Revised written submission from the Prince Albert Grand Council

**Regulatory Oversight Report for Uranium
Mines, Mills, Historic and Decommissioned
Sites in Canada: 2017**

CNSC Participant Funding Program—Regulatory Oversight Report (ROR) on Uranium Mines, Mills, Historic and Decommissioned Sites in Canada 2017

Responses to the Regulatory Oversight Report on Uranium Mines

Figure 1 Gunnar Mine—open pit, circa 1962

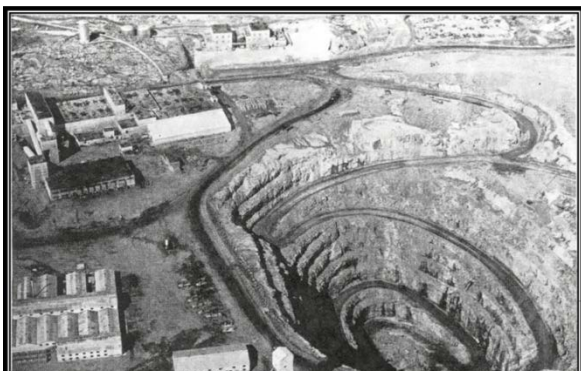
Flooding in mines is a common issue, the associated risks of which, relate to health and environmental concerns. The figures below provide evidence of the flooding in Gunnar Mine

in c.1962 and 2006 res. According to the ROR, there is no liquid effluent at the Gunnar site; however, there is overland flow and seepage from the site into local water bodies. (Page 115 of ROR). Present research suggests that with the warming weather trends, rainfall/precipitation rates may increase in the future in Arctic and Mid-Arctic Canada (See <https://www.enr.gov.nt.ca/en/state-environment/13-projected-trends-temperature-and-precipitation-arctic>); however, we are unsure what this means for the overall risk of flooding of mine pits or tailings.

Questions: *Is there any information on the risk of flooding the mines of the Black Lake, Saskatchewan area?*

Does CNSC have any flood mapping (flood hazard risk assessment) of the 37 abandoned uranium mines to measure the risk of overflows of mine pits or flooding of tailing ponds?

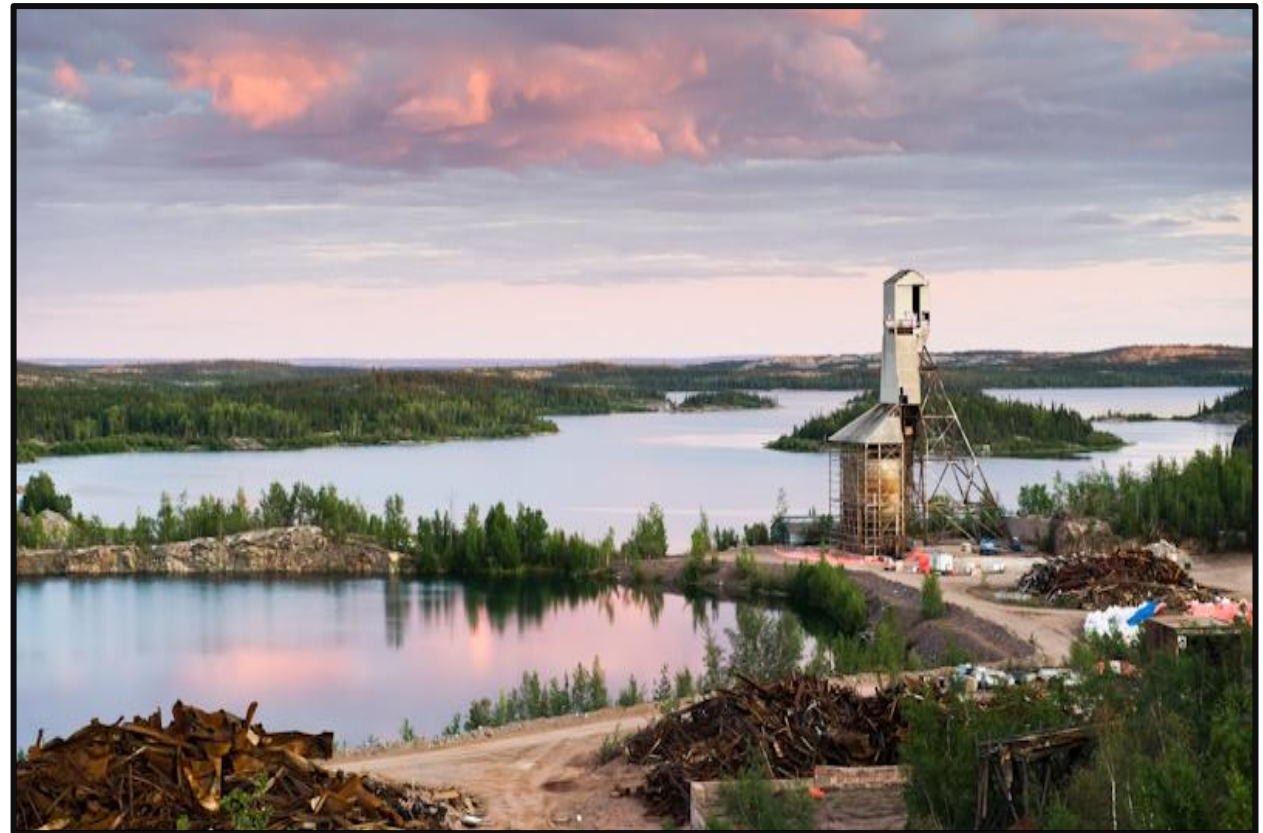
Northern Saskatchewan's 37 abandoned mines

- Not much consideration taken for environmental protection
- Mining projects were not heavily regulated or reclamation was not done
- Deteriorated mines posed risks to residents and the environment
(Source: Project CLEANs: <https://www.src.sk.ca/project-cleans/mine-and-mill-sites>)

Question: Can CNSC provide an update on the management of the abandoned mines up north such as those around the Lake Athabasca area?

Comprehensive monitoring-bigger footprints

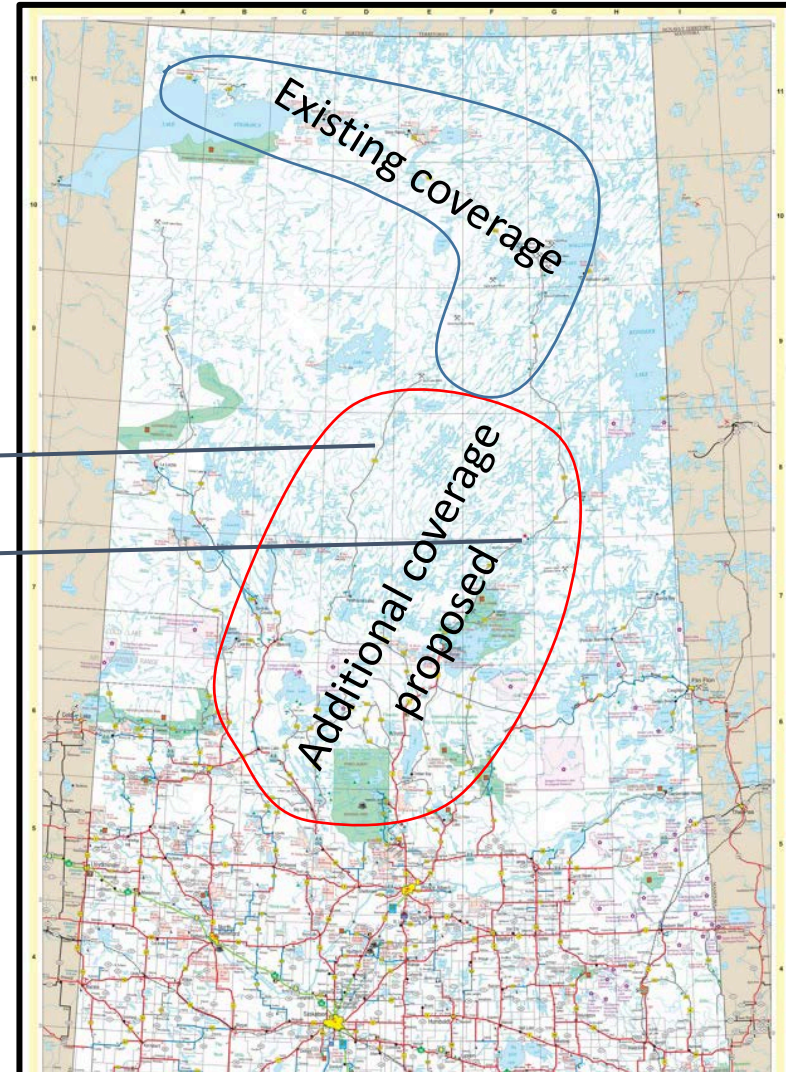
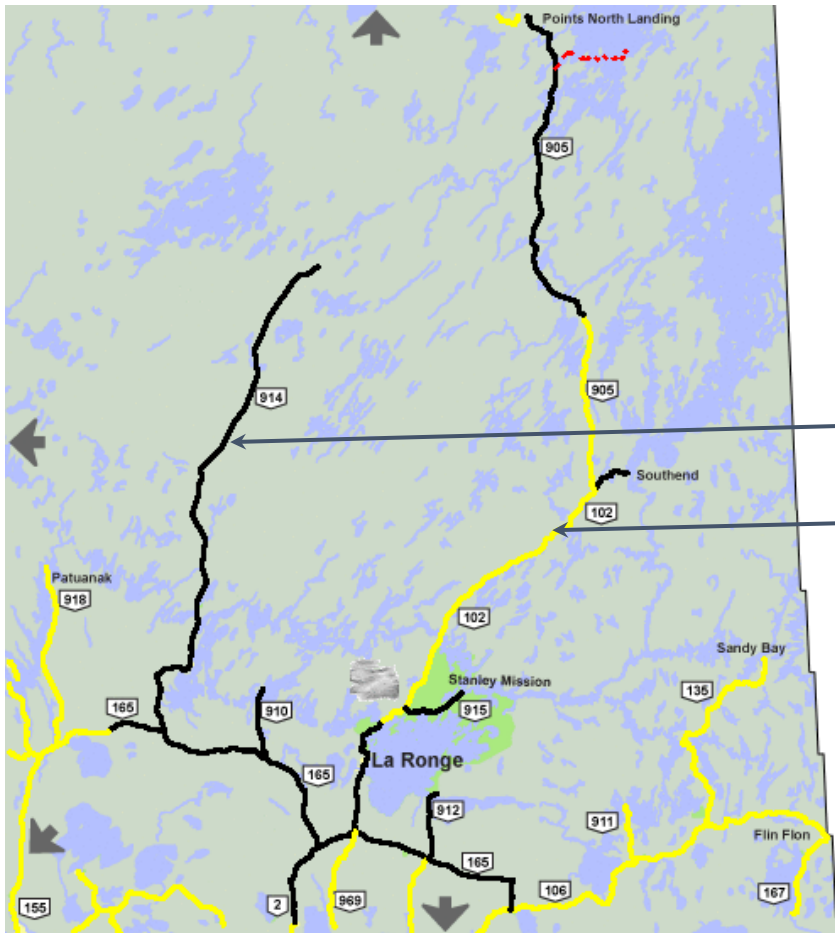
How about a caribou and moose habitat monitoring considers the areas beyond its present sample collection zone covering areas surrounding the HWY- 914 and 102 that are far south? These two roads are also used for mining and other purposes have caused habitat fragmentation.
